Fourth Preliminary Consultation
MONTGOMERY COUNTY HISTORIC PRESERVATION COMMISSION
STAFF REPORT

Address:	22200 Clarksburg Road, Clarksburg	Meeting Date:	1/27/2021
Resource:	Master Plan Site #13/25 <i>Cephas Summers House</i>	Report Date:	1/20/2021
Applicant:	Pulte Homes (Randall Rentfro, Agent)	Public Notice:	1/13/2021
Review:	4 th Preliminary Consultation	Tax Credit:	N/A
Case Number:	N/A	Staff:	Michael Kyne
Proposal:	Demolition and reconstruction

The applicants propose demolition and reconstruction of the historic Cephas Summers House.

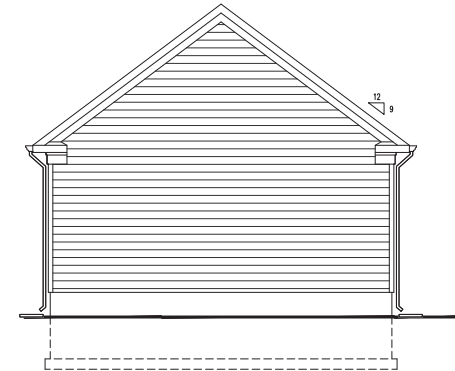
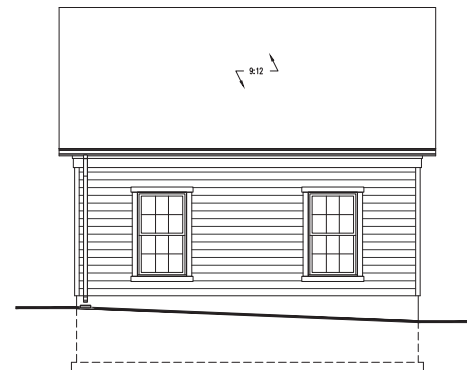
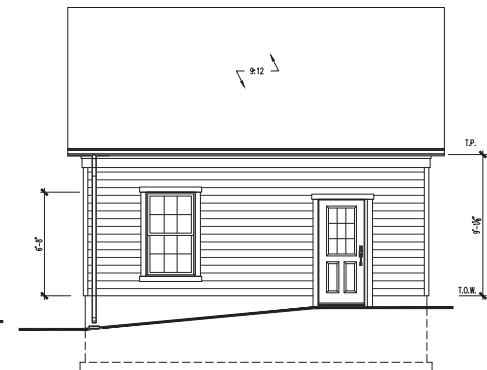
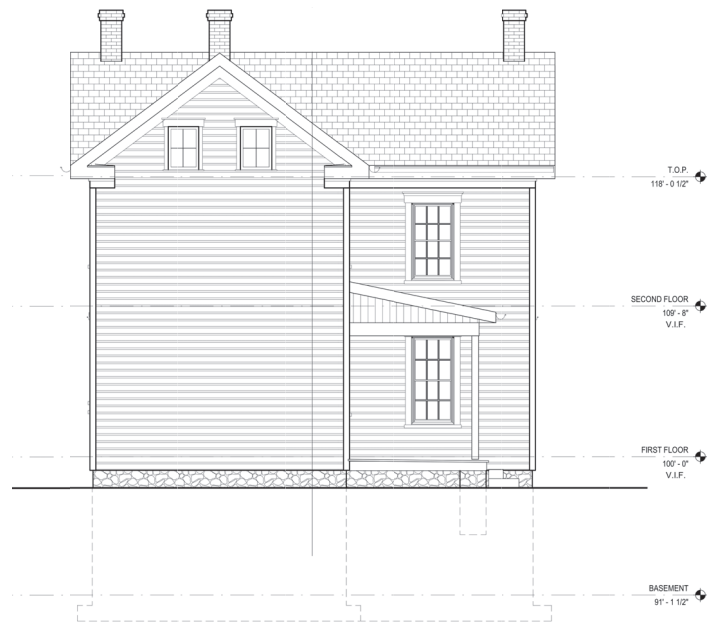
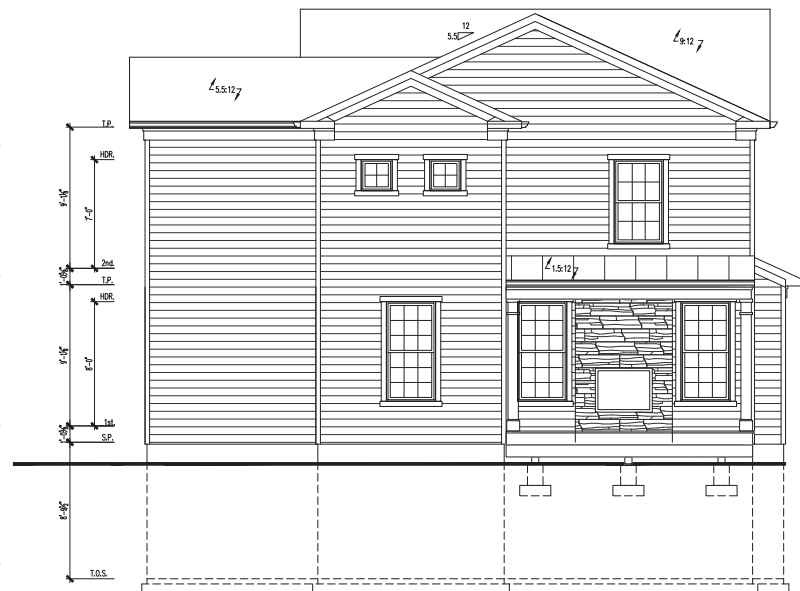
The façade of the proposed new building will take visual cues from the façade of the historic house, but it will be slightly taller (the existing eaveline is 17'-11 1/8" from grade, while the proposed eaveline will be in excess of 20' from grade). The fenestration on the side elevations of the proposed elevations will also differ slightly from the existing.

As proposed, the new building will not have a traditional ell. Instead, the width of the building at the rear

will be equivalent to the front. A small one-story bumpout is also proposed at the southwest corner (rear/left, as viewed from the public right-of-way of Clarksburg Road). An approximately 11' wide two-story projection is also proposed at the northwest (rear/right) corner, and a 12' deep two-story projection is proposed at the west (rear). While significant, the setback of the northwest projection will be set back in excess of 28' from the façade.

- The proposed new building should have the same general form and expression as the historic house, including the rear ell and fenestration pattern on all elevations.

- At the very least, the proposed new building should be designed with insets and/or greater articulation at the rear portions, allowing the original Cephas Summers House form to be prominent and clearly discerned.

- Staff is not greatly concerned with the additional height of the proposed building.
- The proposed new building should be constructed with traditional or appropriate and compatible new materials.

Cephas-Summers Home

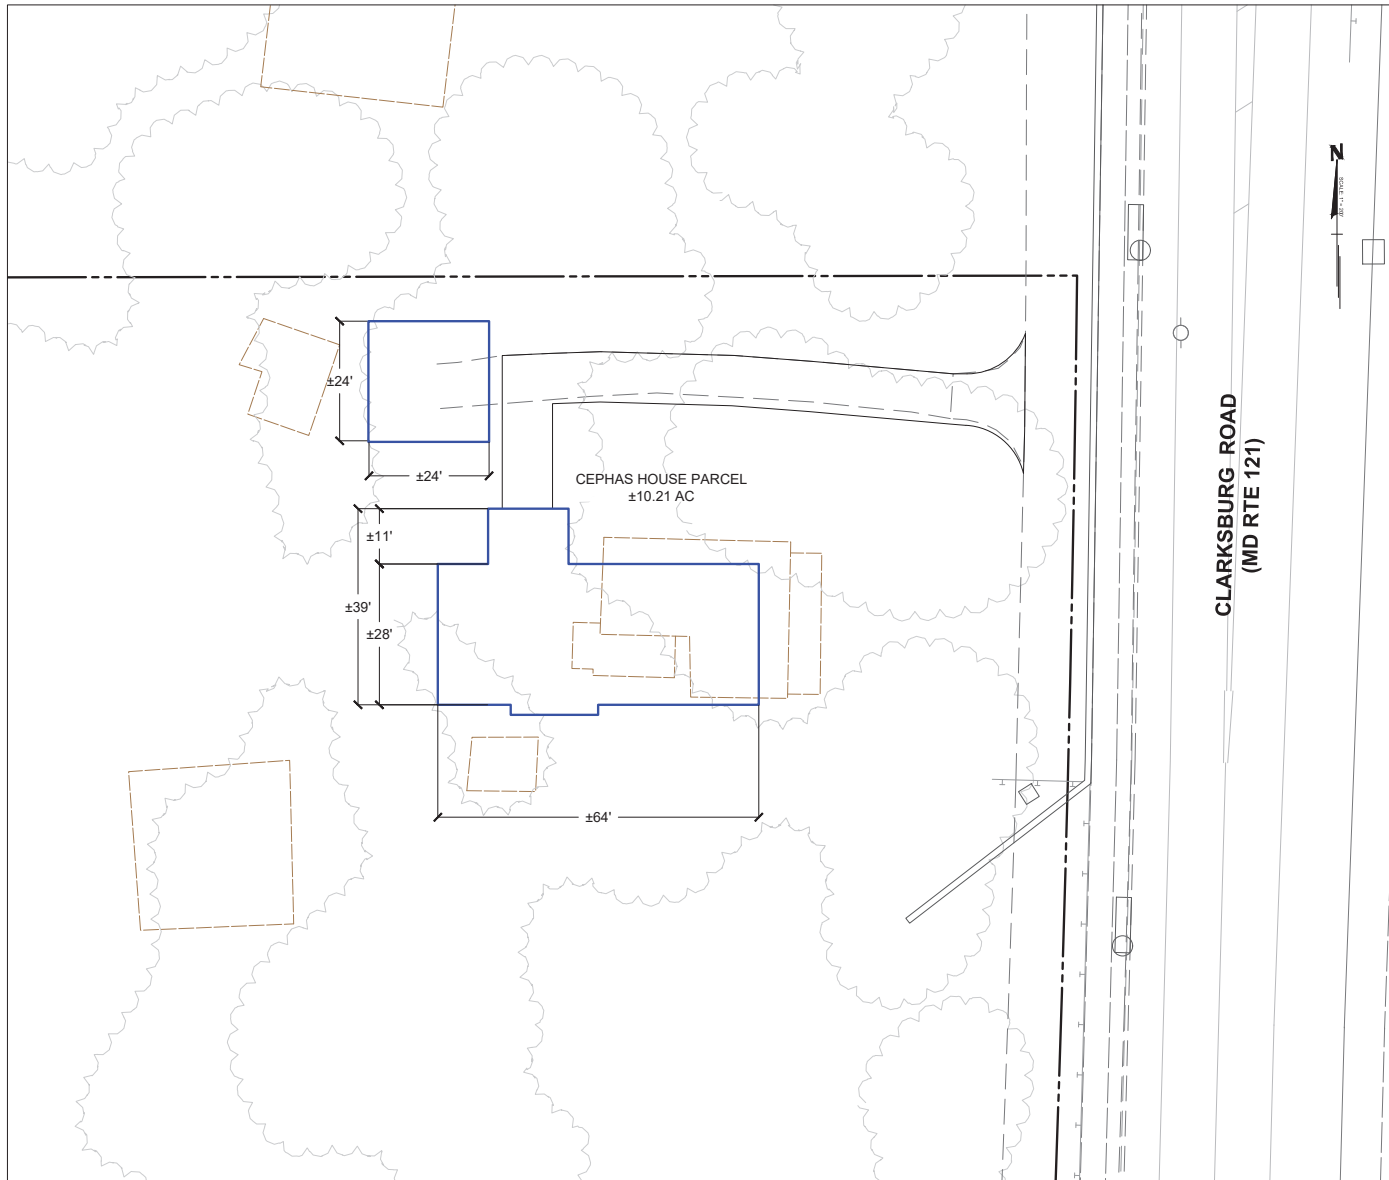
- While traditional wood clapboard siding is preferred, staff would support the proposed millable and paintable fiber cement siding; however, staff recommends smooth-faced fiber cement siding (in the past, the Commission has found that the wood grain option has the appearance of poorly maintained wood siding).

- Typically, vinyl windows do not accurately replicate traditional wood windows in their visual qualities, finishes, construction method, and the manner in which they weather and age. Accordingly, the proposed windows should be wood. windows, with permanently affixed interior and exterior muntins with spacer bars.

- When submitting the HAWP application, complete manufacturer's specifications should be provided for all proposed materials, including the main building's foundation.
